CITY OF BELLEVUE, IDAHO
Planning and Zoning Commission
Monday, March 3, 2025, 5:30 PM
115 Pine Street, Bellevue, Idaho 83313

a. LLA-25-01 – TBD Lewis Lane – Judy & Keith Meyers – Continued from February 18, 2025

An application for a lot line adjustment for Lots 1-6, Block 96 of the Bellevue Townsite Original Plat. The proposed lot line adjustment will reconfigure the existing six (6) parcels into three (3) parcels and include a request for waivers from code requirements.

PLAN VIEW: PROPOSED ALLEY SECTION
SCALE: 1" = 20'

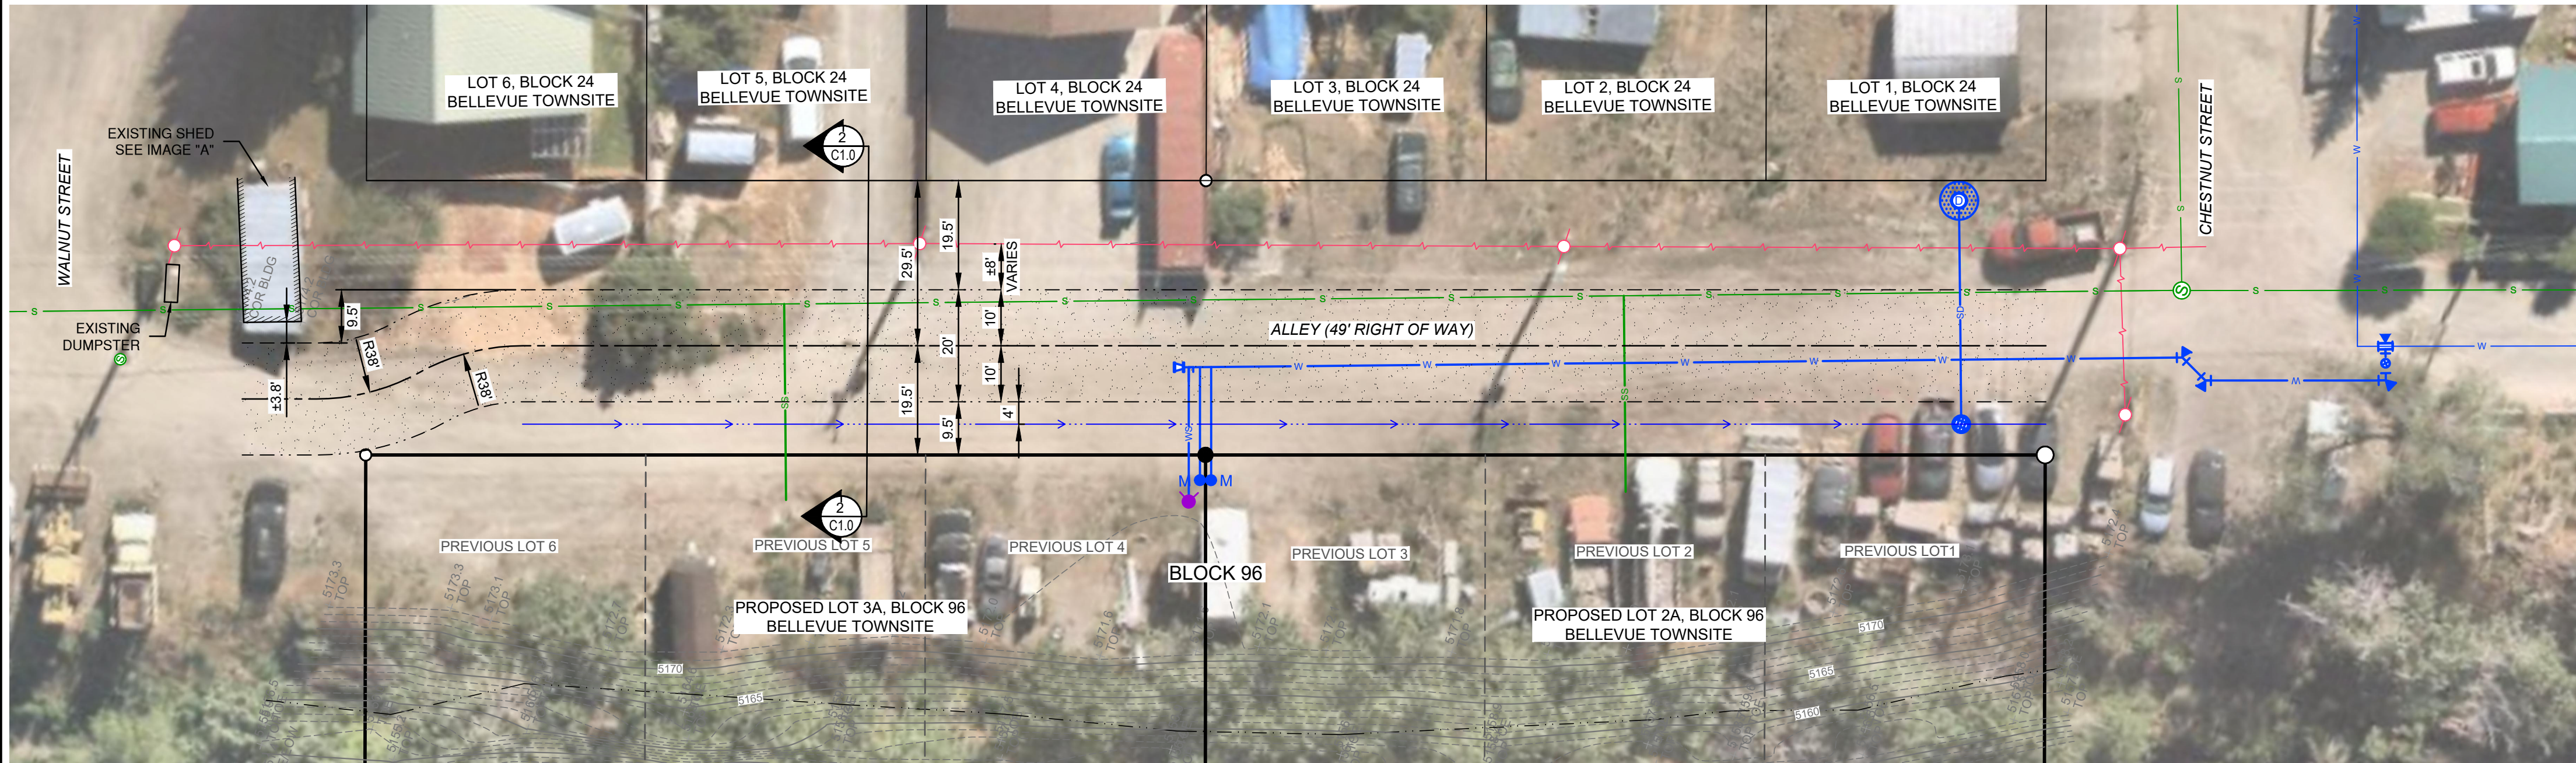
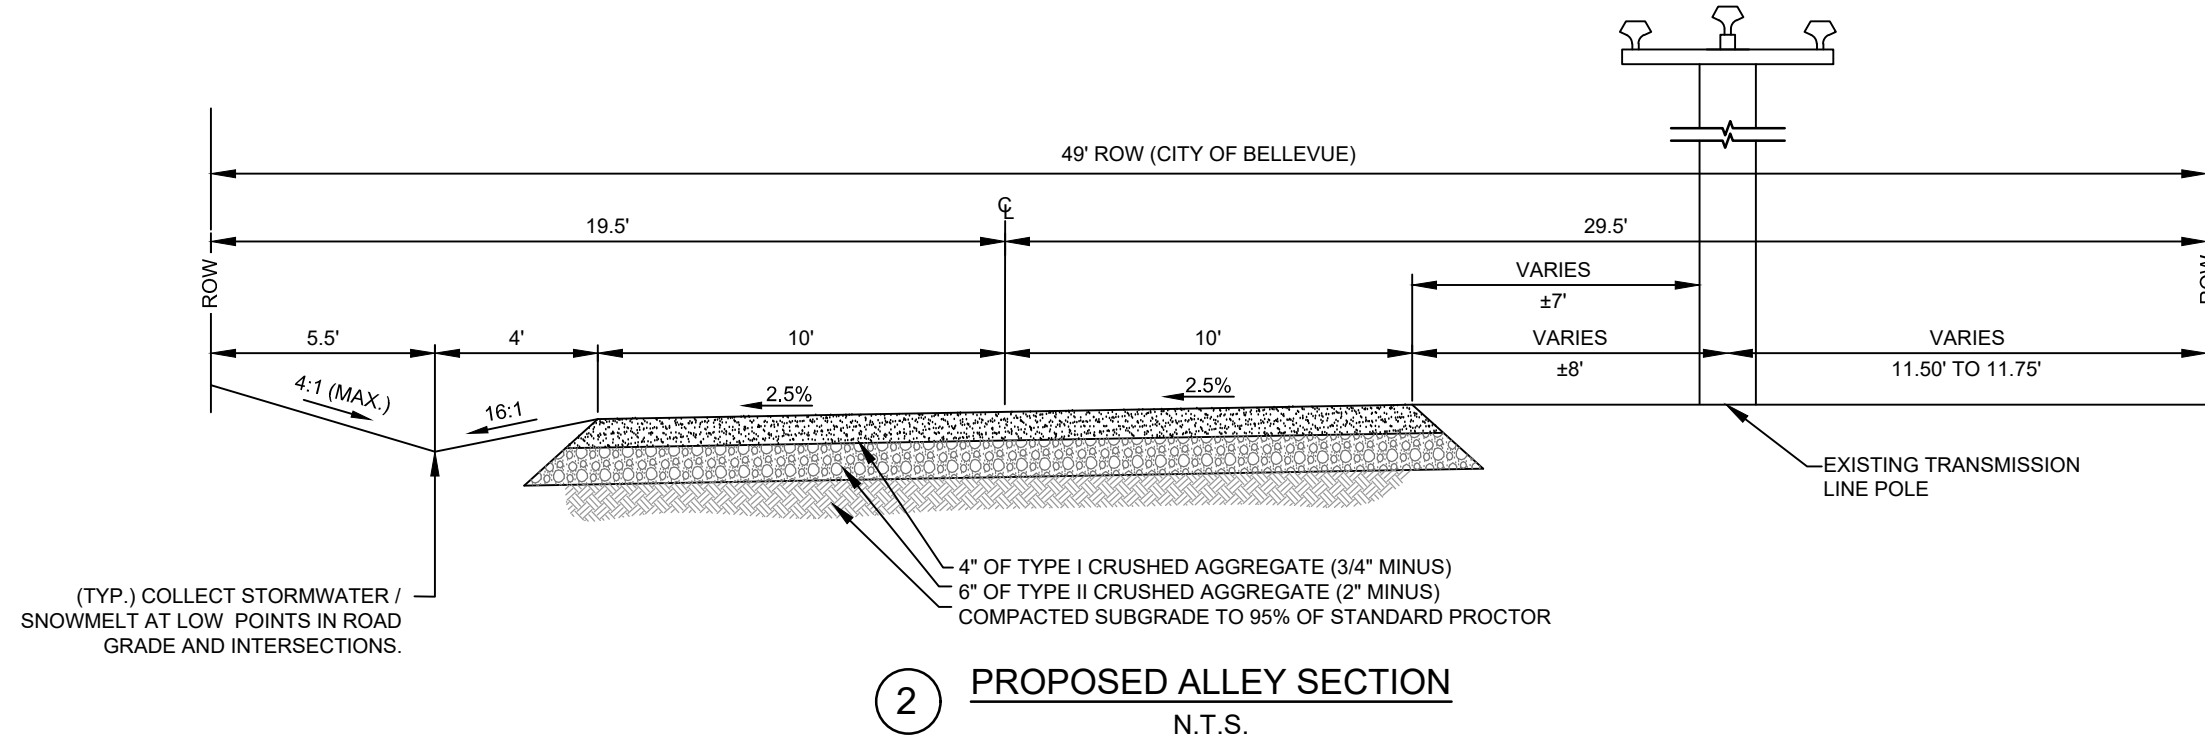
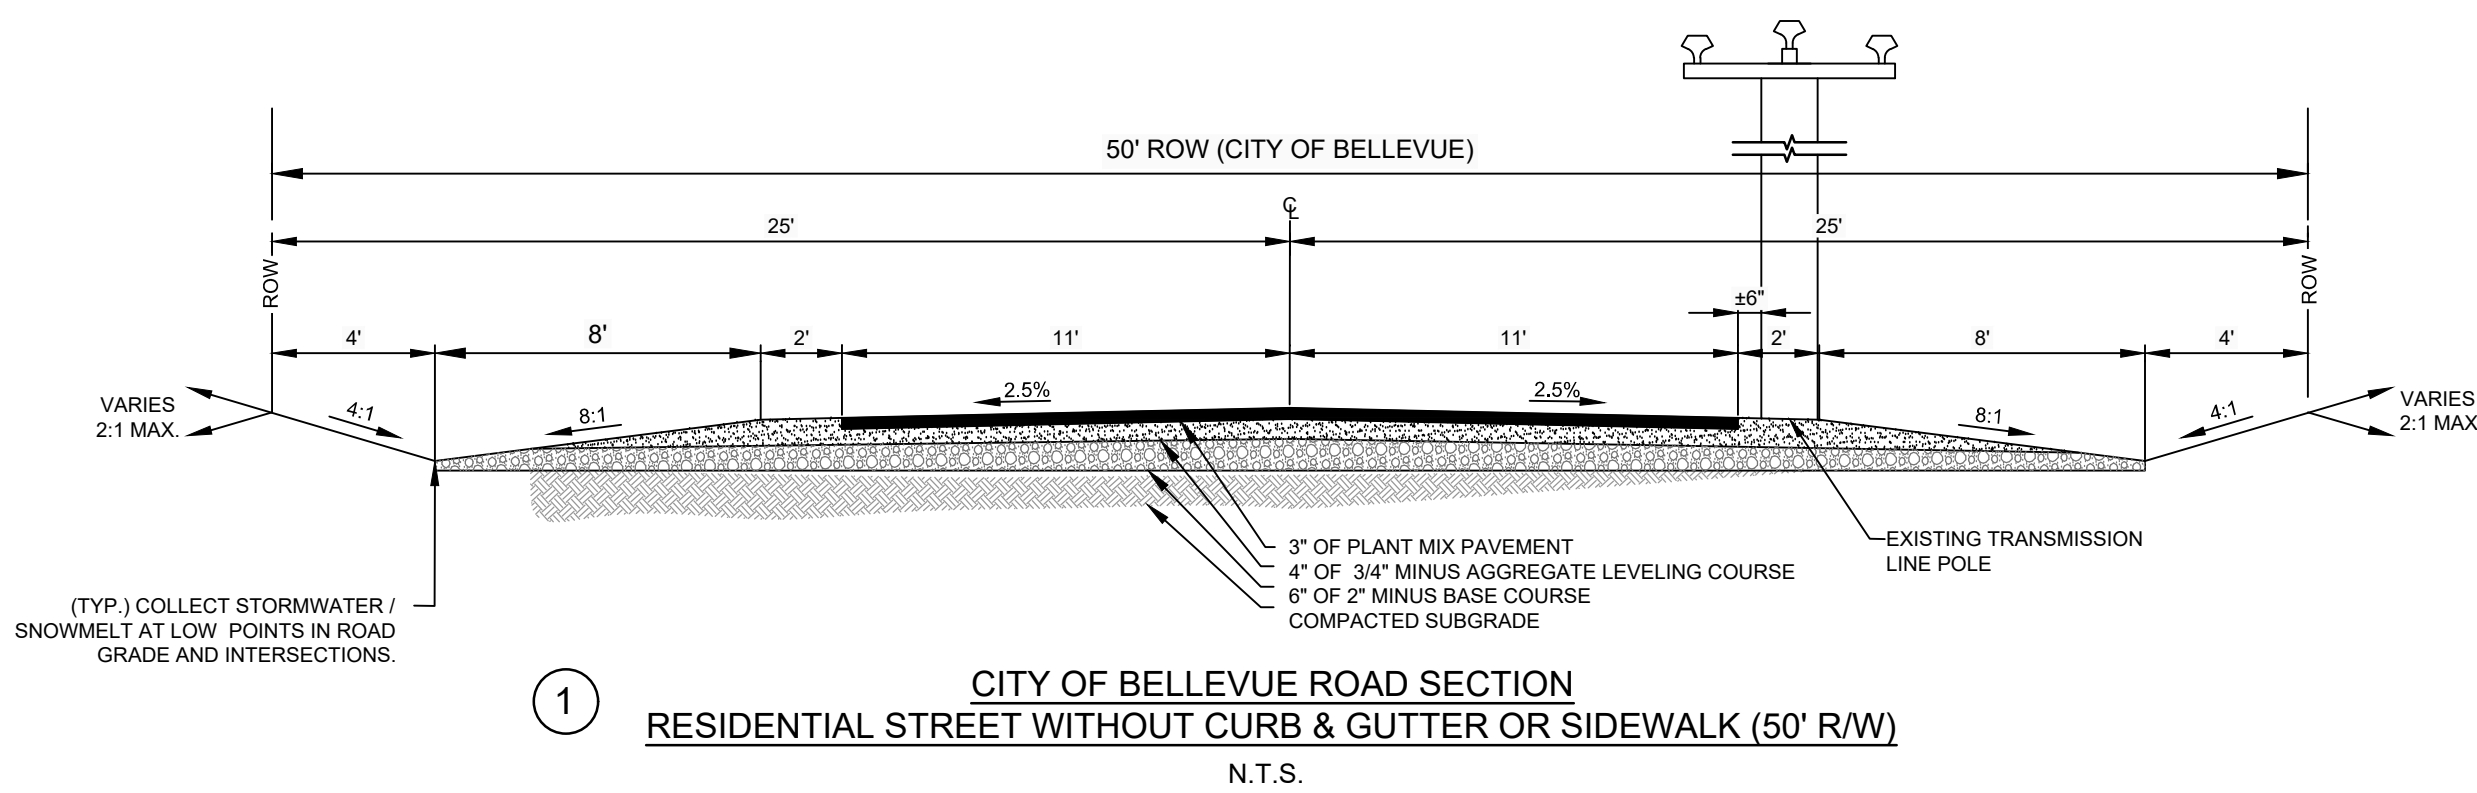
Request waiver and modification to state: "The alley between Chestnut and Walnut shall be improved in accordance with the submitted site specific Alley Improvements Exhibit, EX2, prior to approval of the final plat."

Special physical characteristics/conditions affecting the property in question: Existing overhead transmission lines and four poles encroach approximately 15 feet into the alley ROW on the east side. Other encroachments including trees and fences also exist within the eastern portion of the alley.

Not detrimental to public welfare, health, and safety nor injurious to the property owners in the immediate area: Modifications to the typical street section by (a) shifting the travel lanes 5.25 feet west of center, (b) surfacing with gravel versus asphalt, and (c) changing from a crowned surface to a shed surface with drainage on the west side only, will not be harmful to public safety. A modified street section also is more appropriate because now just two lots are proposed, rather than three as previously approved. Both lots could be accessed via the platted streets of Chestnut and Walnut. The proposed section has been submitted for approval by the Bellevue Fire Chief.

fails to provide any justification for this claim. Encroachments into right-of-way, including power transmission lines are very common within the City of Bellevue. As such, it is Staff's opinion that no "special physical characteristics or conditions" exist that would make literal enforcement (improvement of right-of-way to City standards) an undue hardship. Staff is not supportive of this waiver request.
